VPCH Office Expansion  
155 Queen St N  
Hamilton, ON L8R 2V6

**Construction Tender**  
**ARCHITECTURAL ADDENDUM**  
**No. 03**

Friday, October 06, 2023

1 **EXTERIOR STAIR PLAN DETAIL**  
SCALE: 1:20

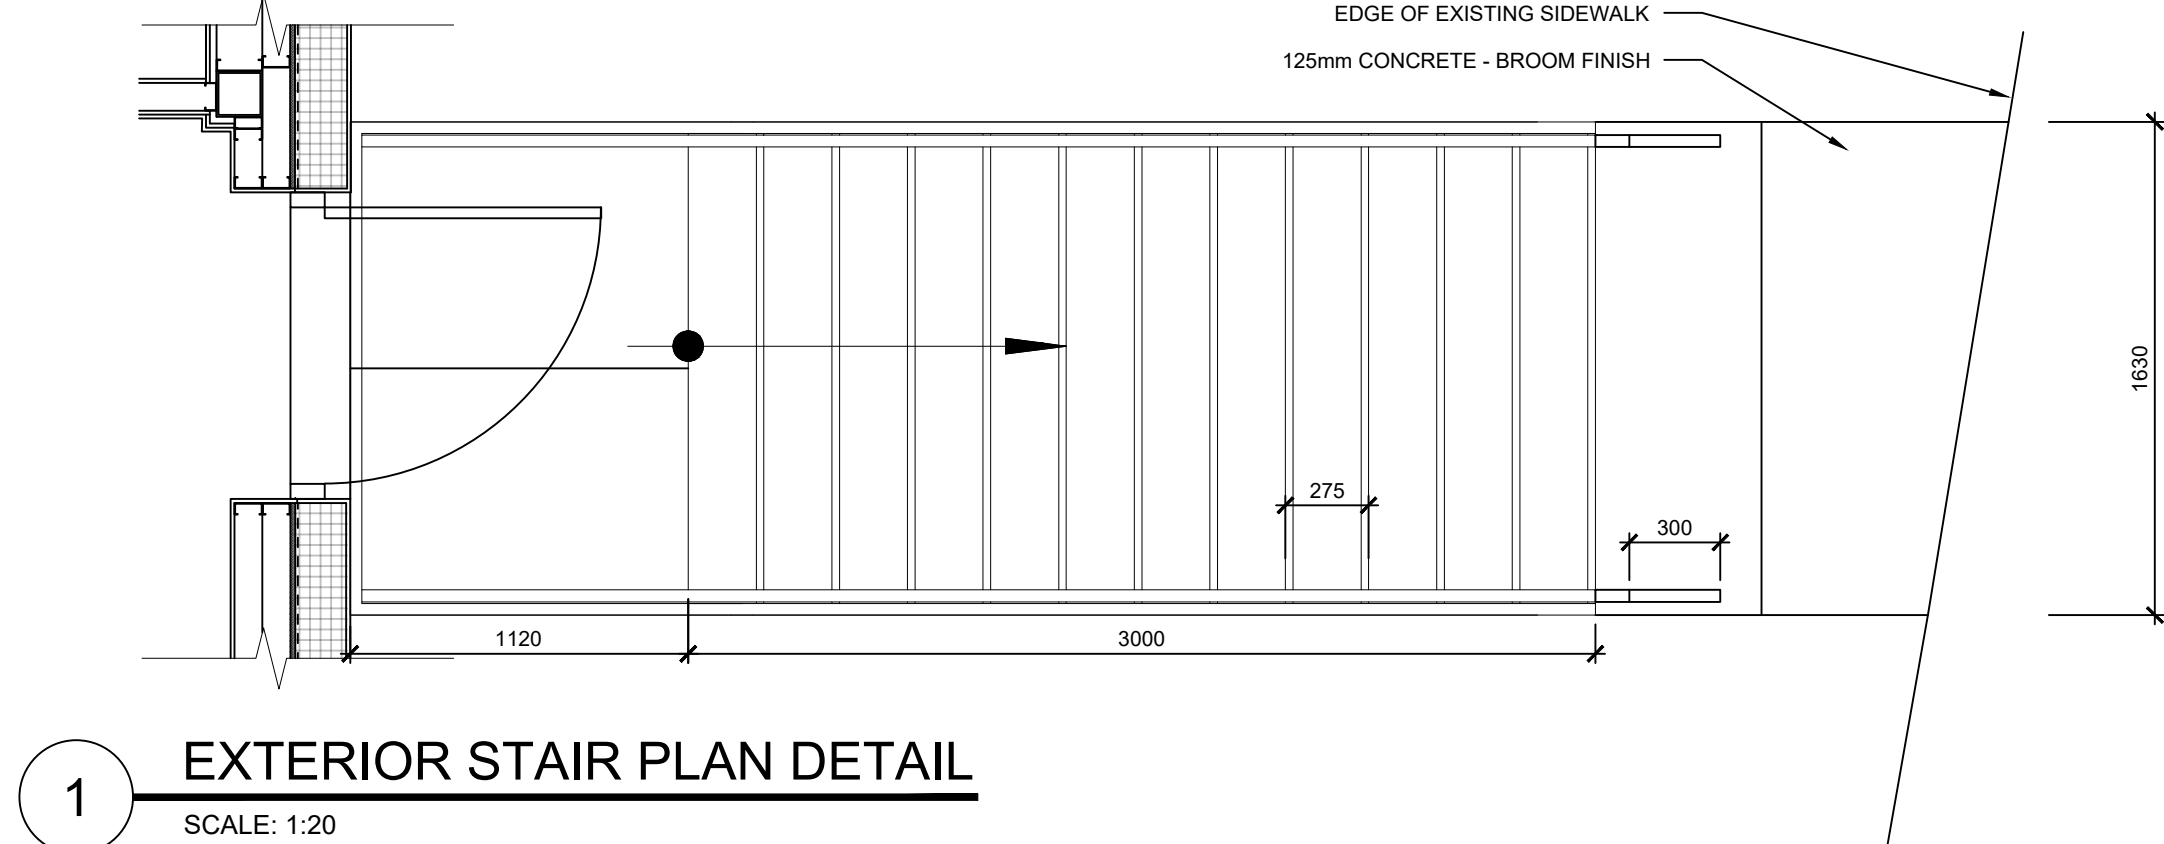
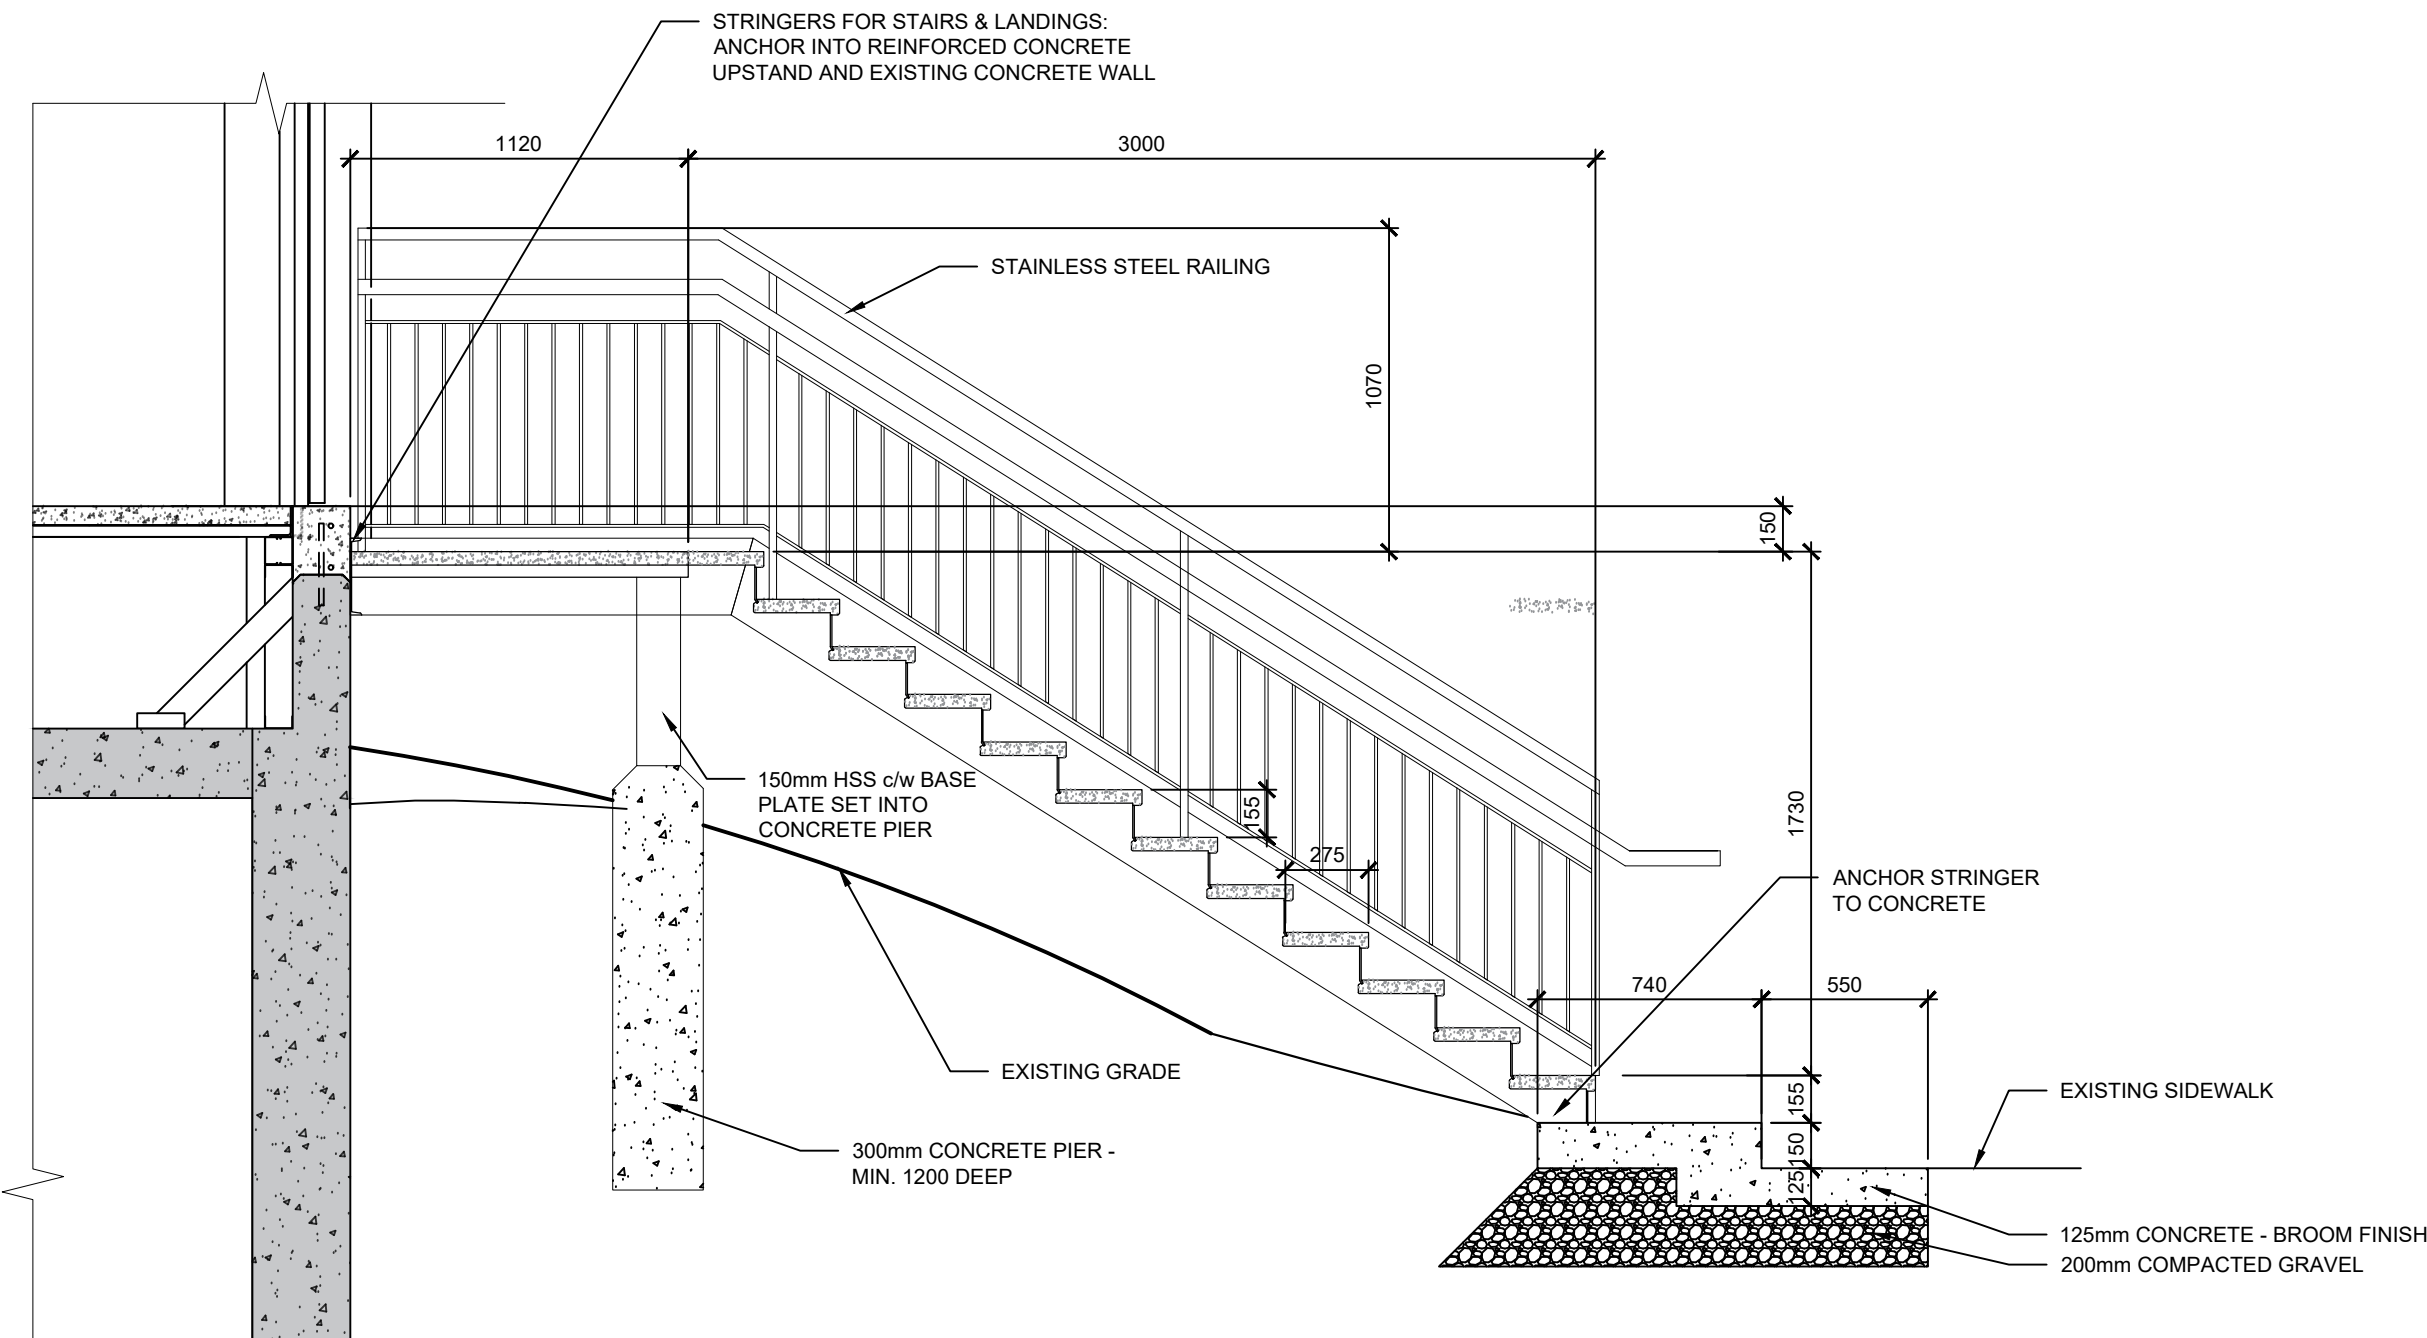
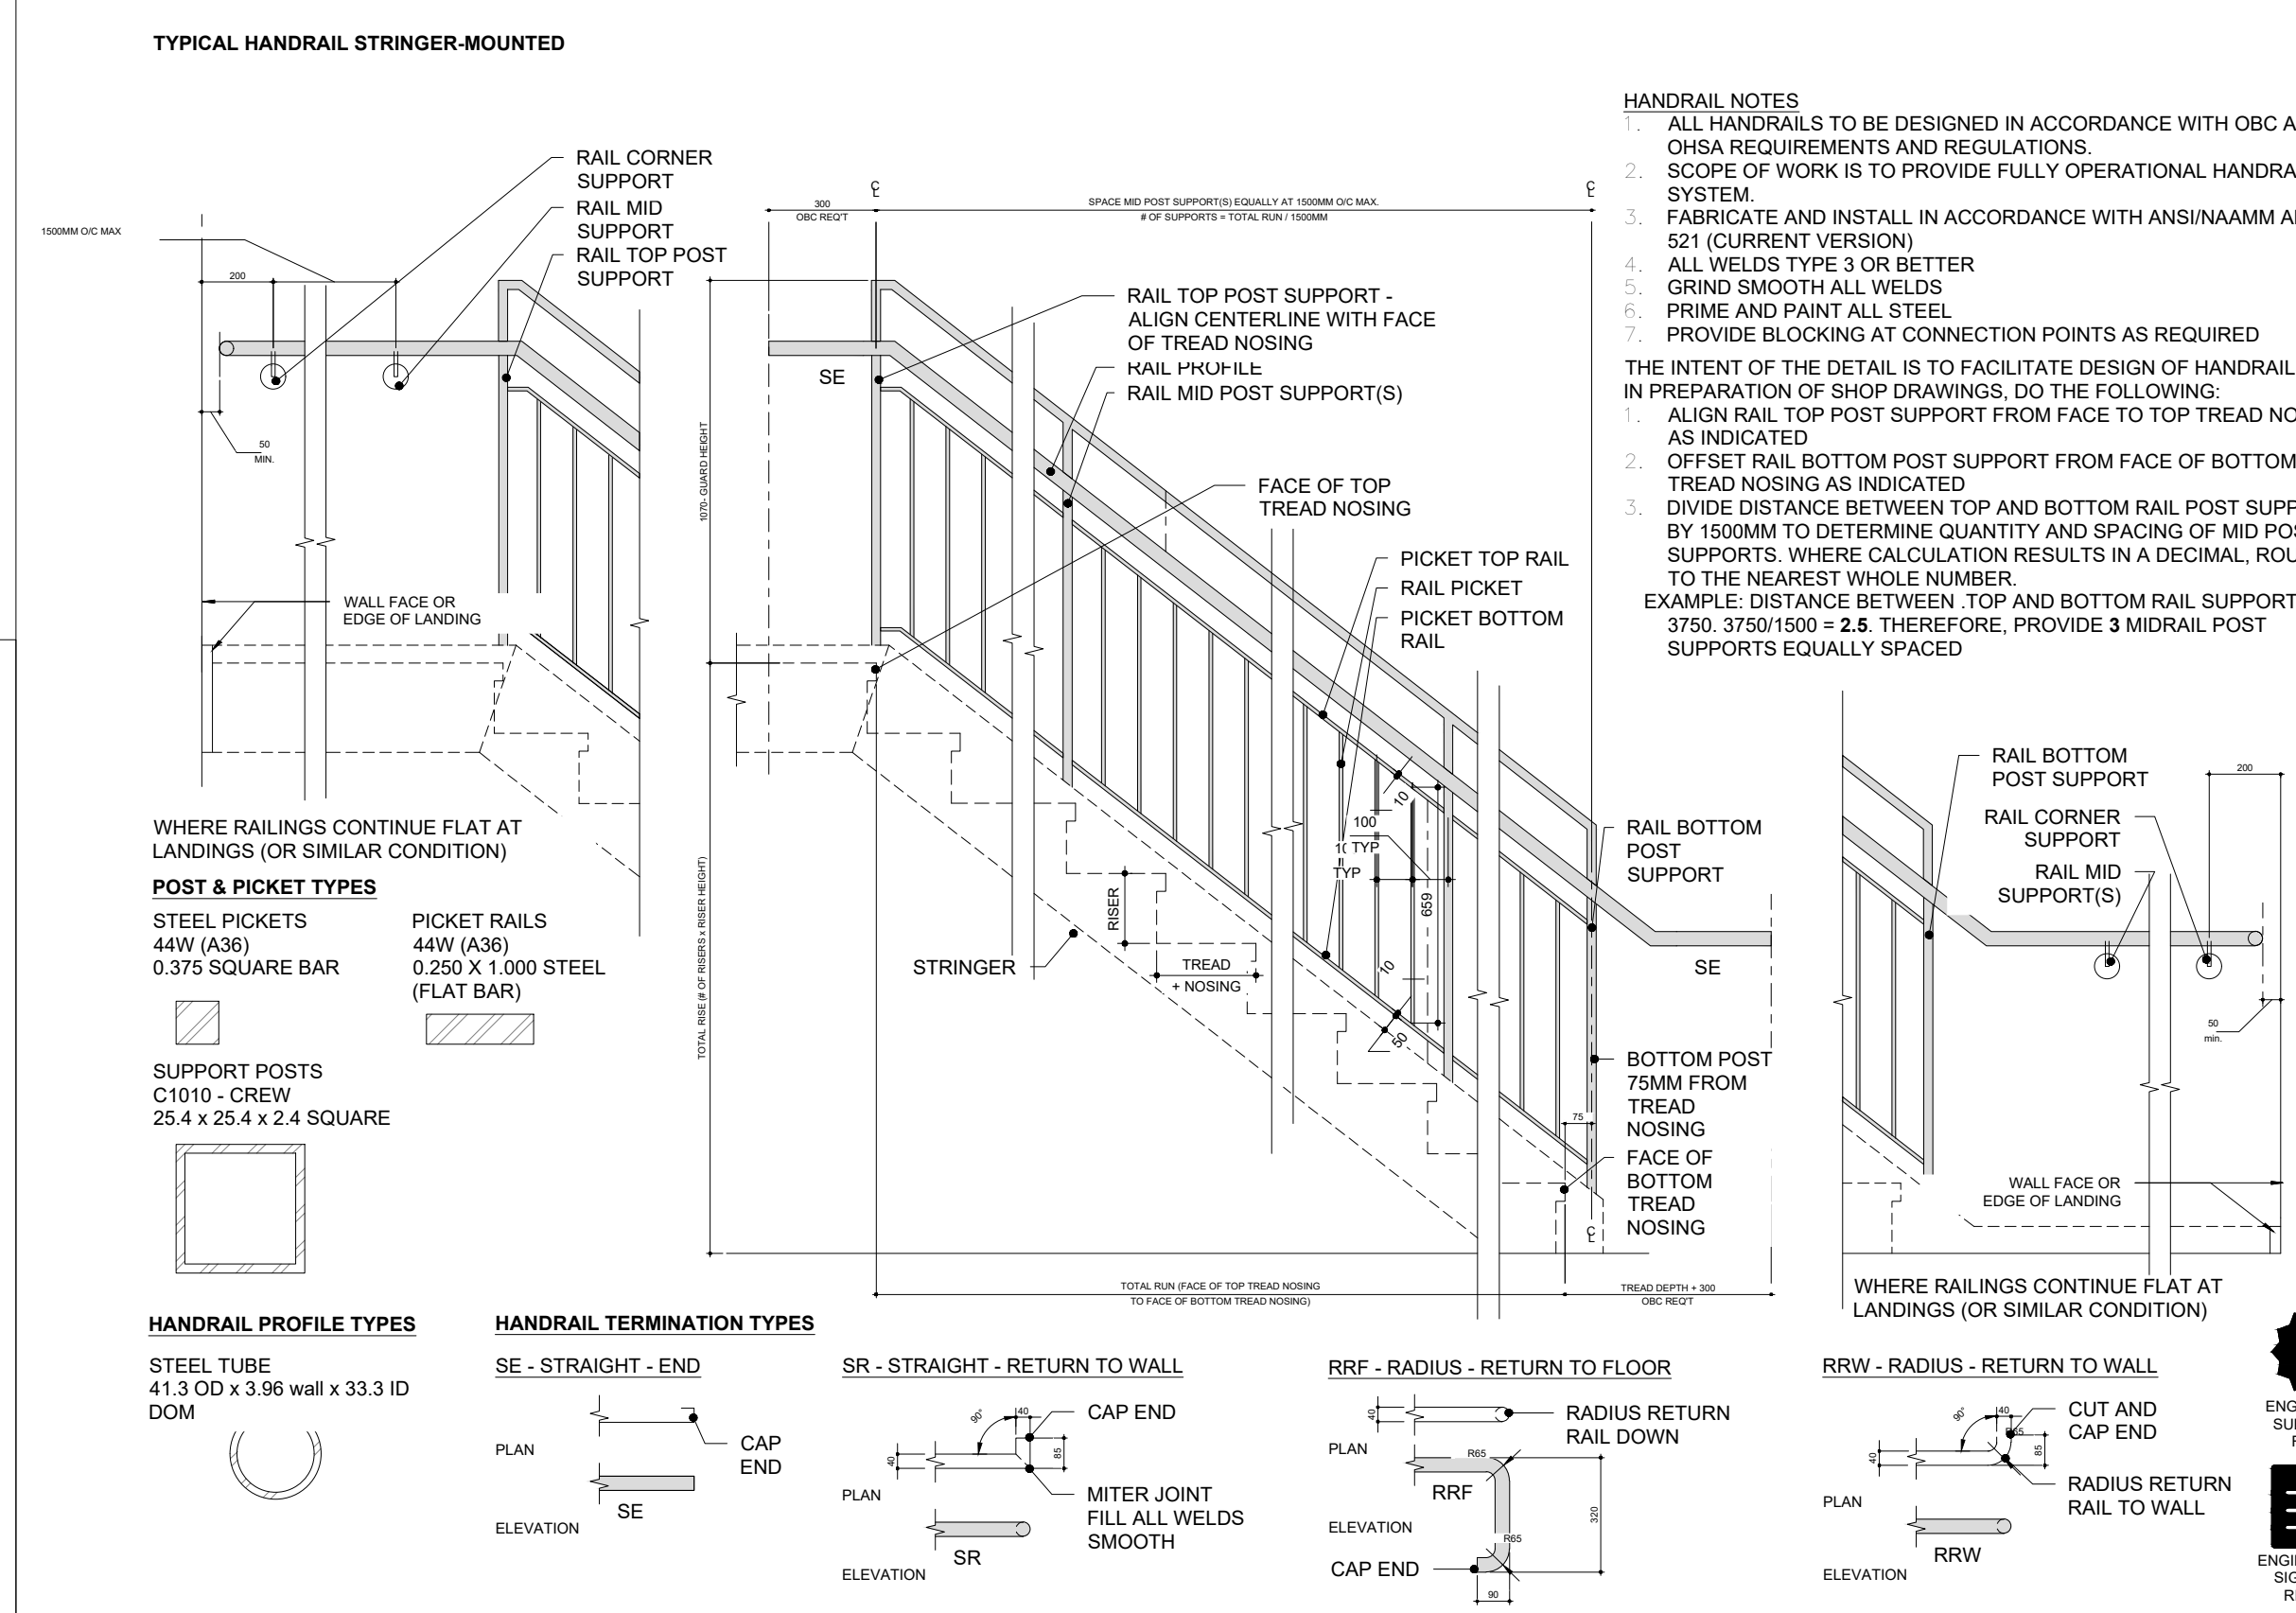
*Could you provide a cross-section for the new exterior stairs shown on A1.05?*

Please provide more detailed drawings for the galvanized steel frame at exit stair as noted on drawing A02.02 detail 1.

*Please refer to section 3. DRAWINGS of this addendum. Drawing A04.05 – Stair Details and Railings.*

Please refer to section 3. DRAWINGS of this addendum. Drawing A04.05 – Stair Details and Railings.
